# Staff Report

**Date:** August 11, 2021

**Re:** PLNPCM2020-00174 West Temple Duplex Planned Development

**PROPERTY ADDRESS:** 1048 S West Temple

L2  
SITE PLAN

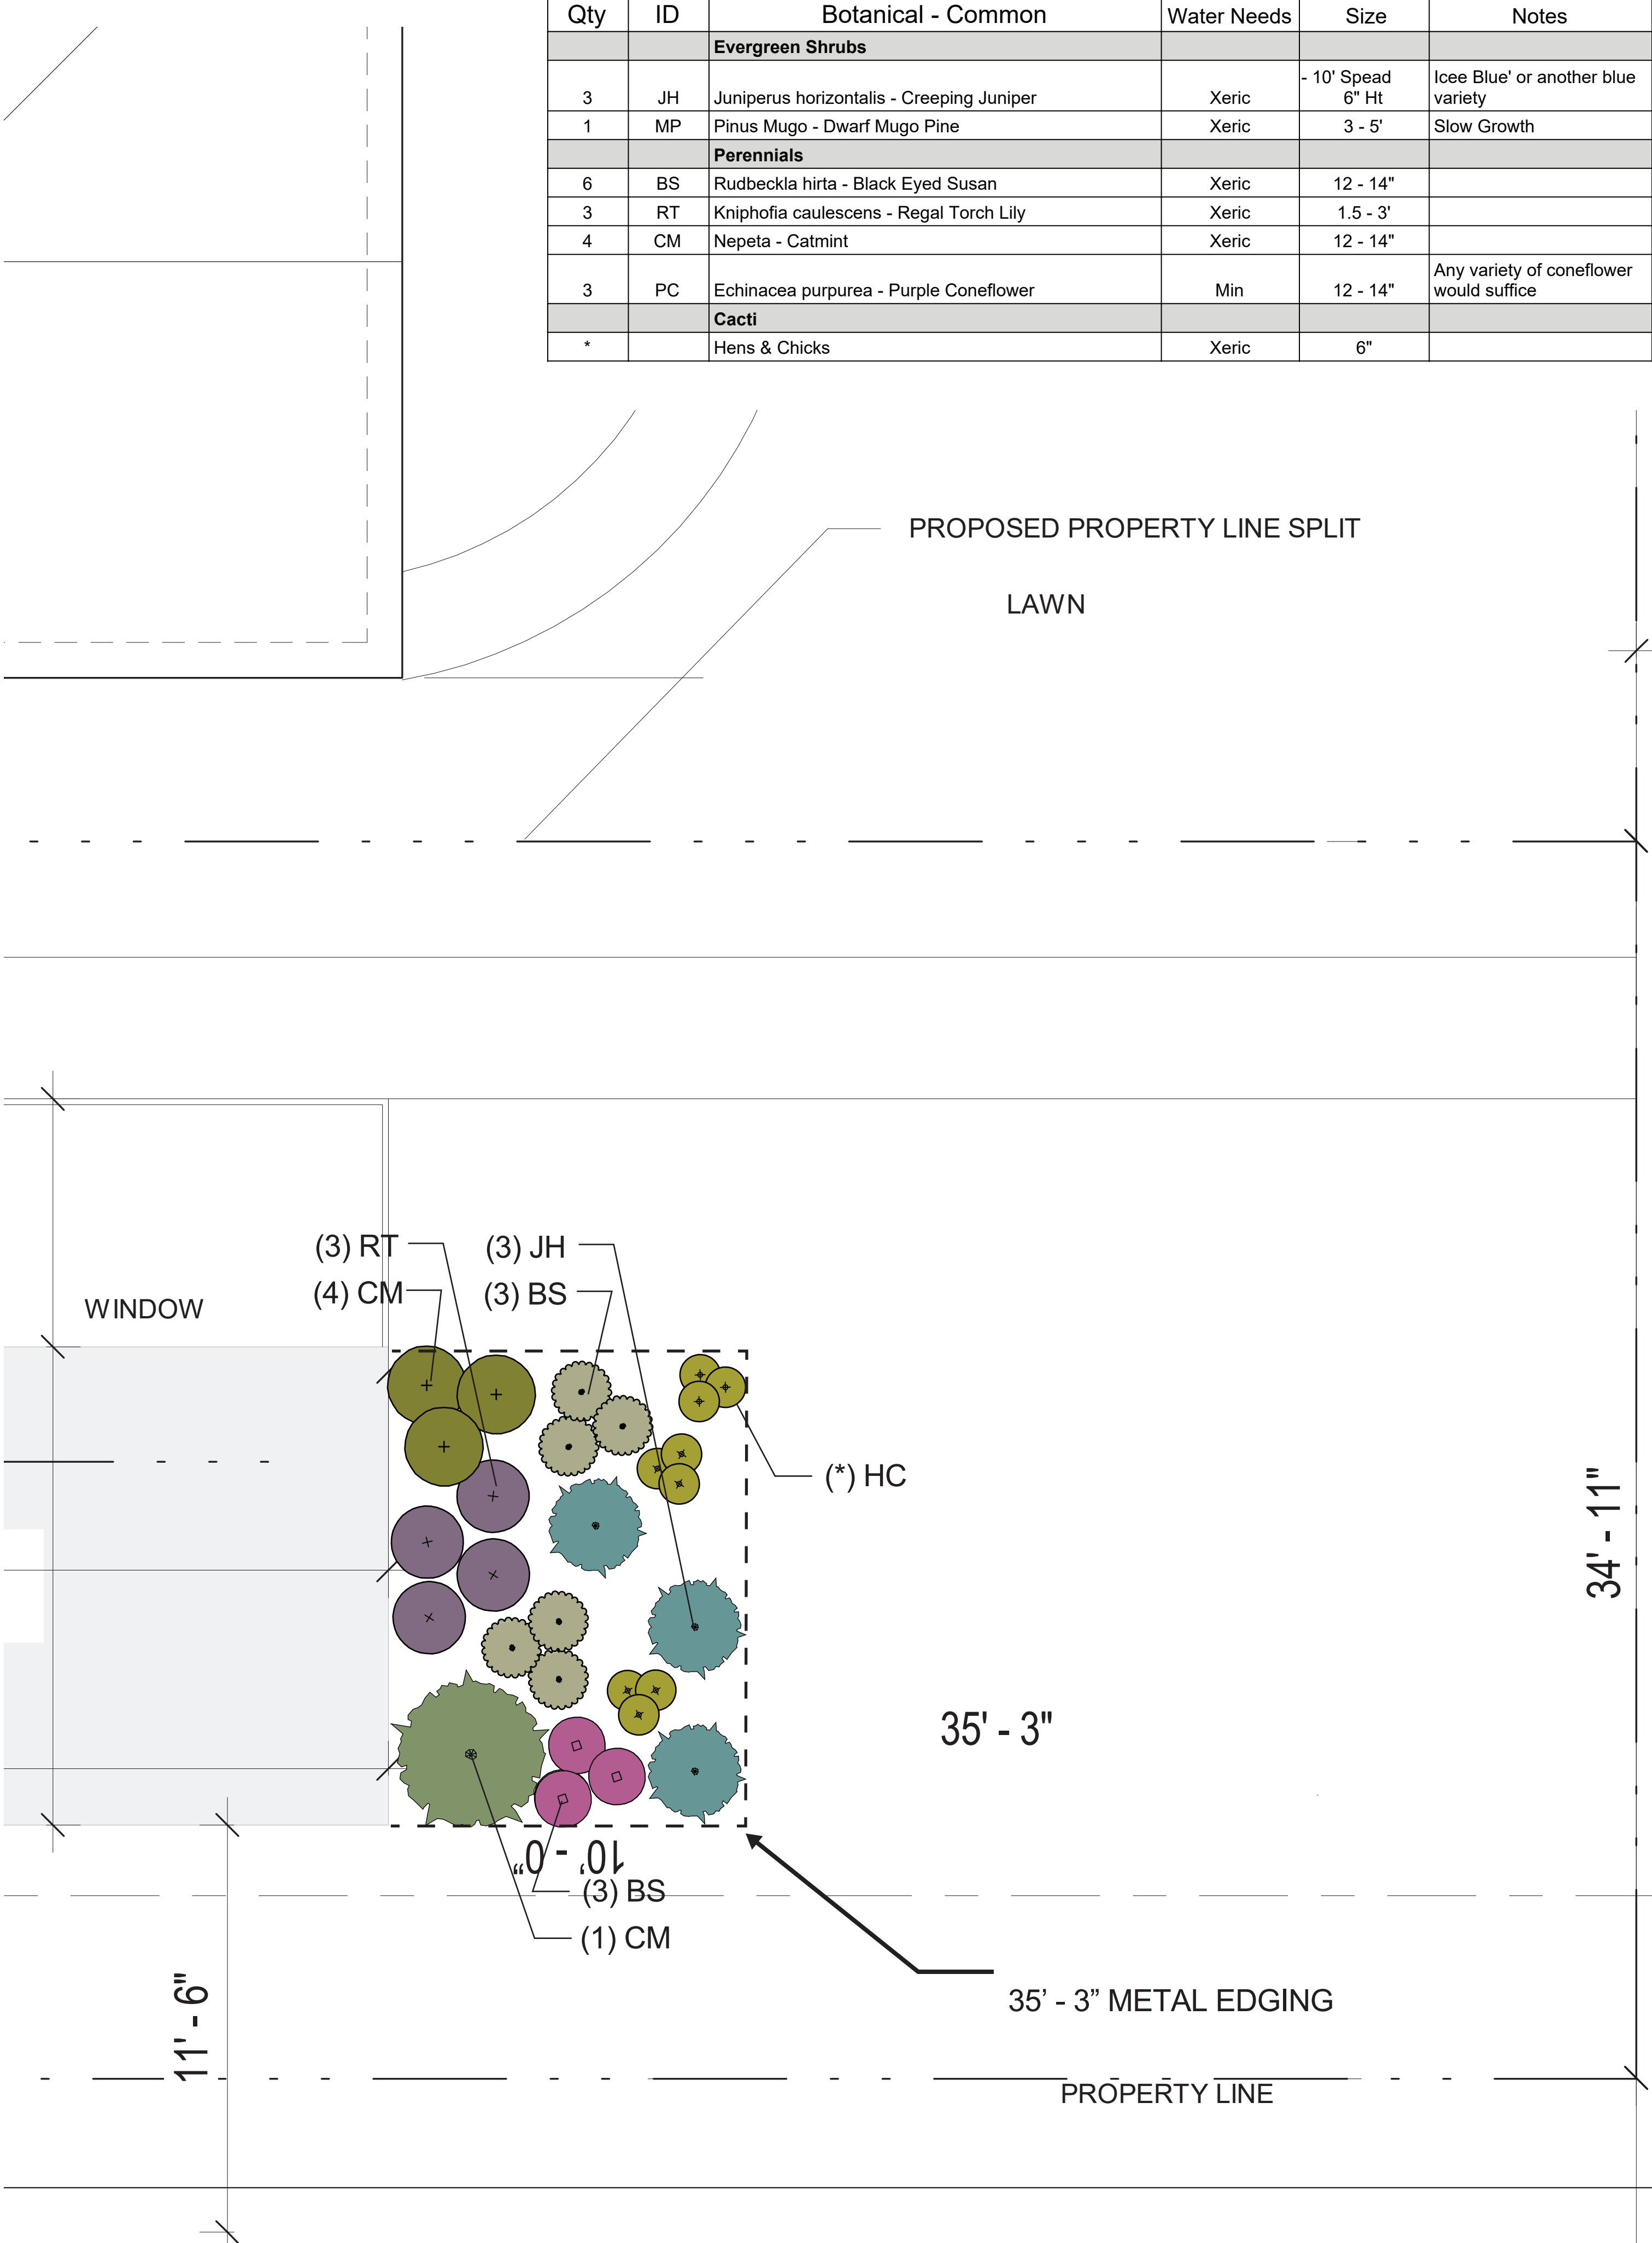
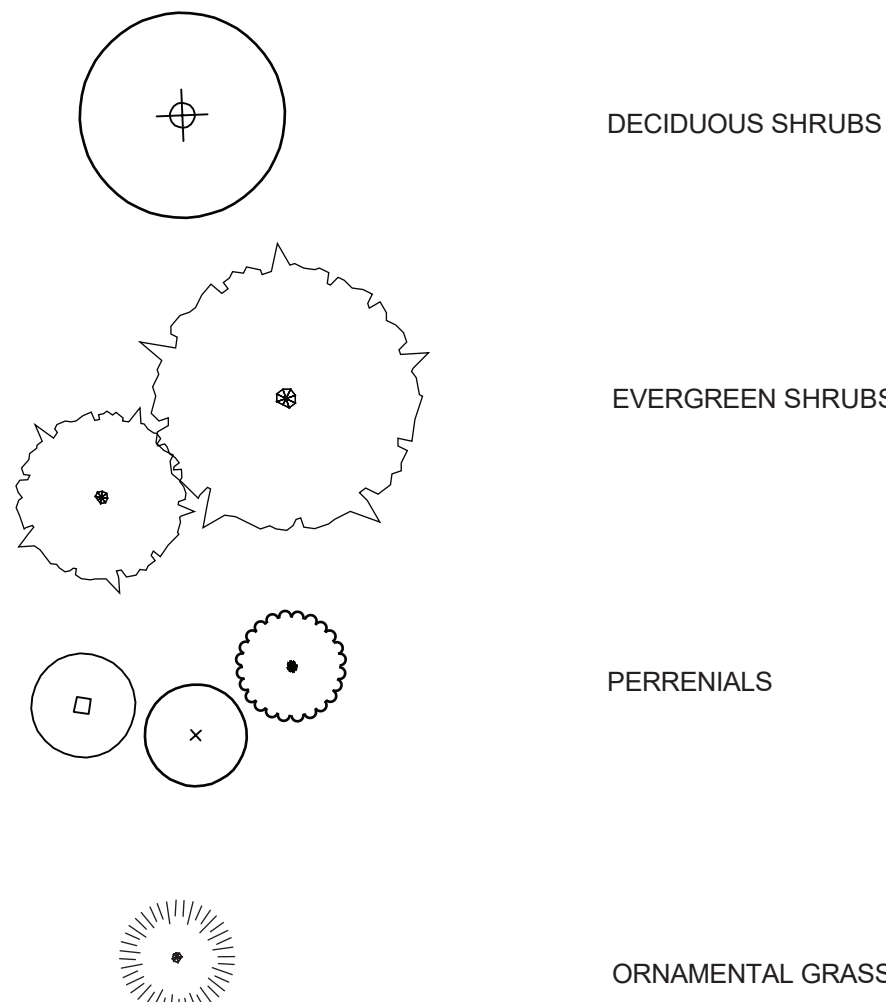
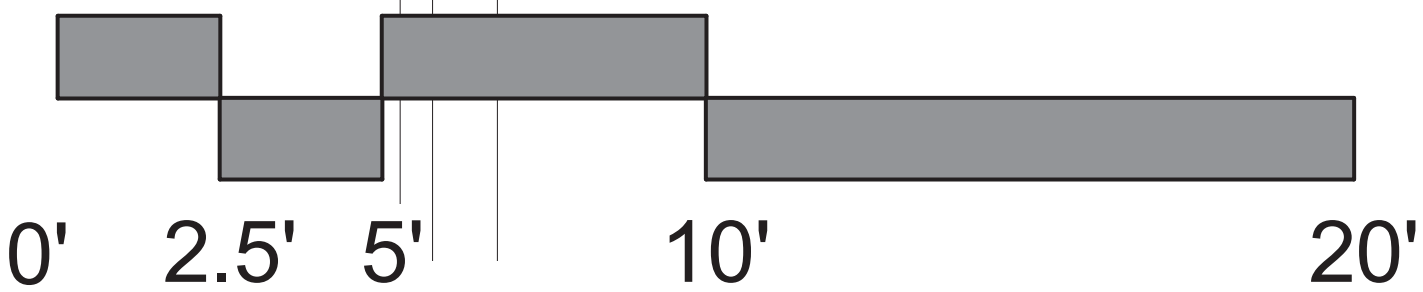
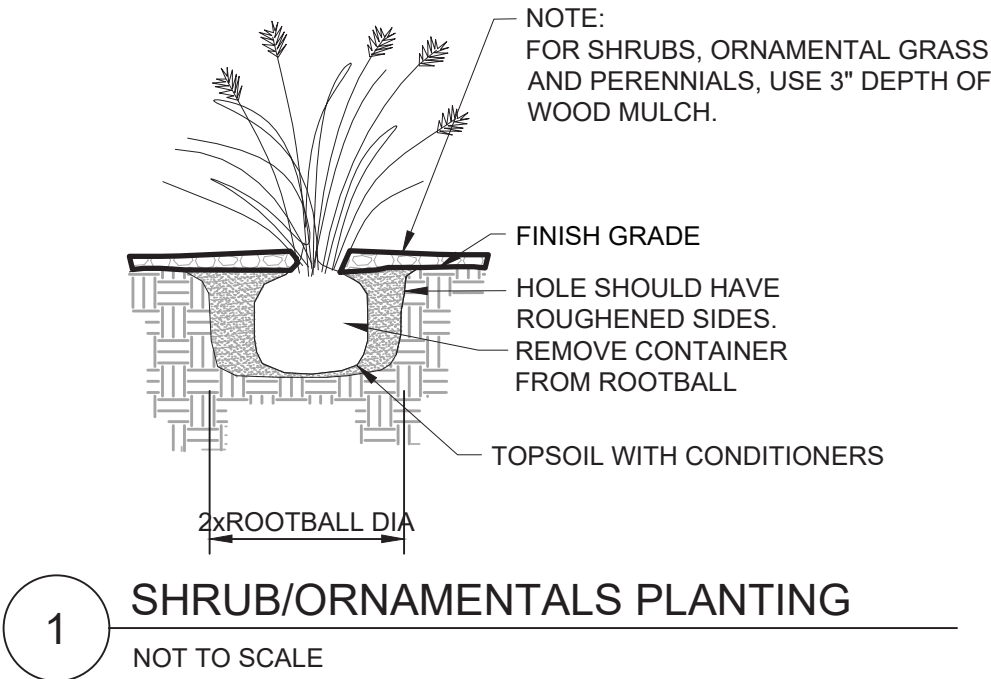
For the proposed two-family use, the site plan shows the applicant is not proposing minimum required parking per 21A.44.030.G. table- 2 vehicle parking stalls for each dwelling unit. On the site plan, two stalls are shown on-site and one stall is shown on the street. All four (4) required parking stalls must be provided on-site for the two-family use per 21A.44.040.B.6. To propose complying parking sizes, locations, on-site.

*Planning Response: The revised site plan shows four legal parking stalls on-site.*
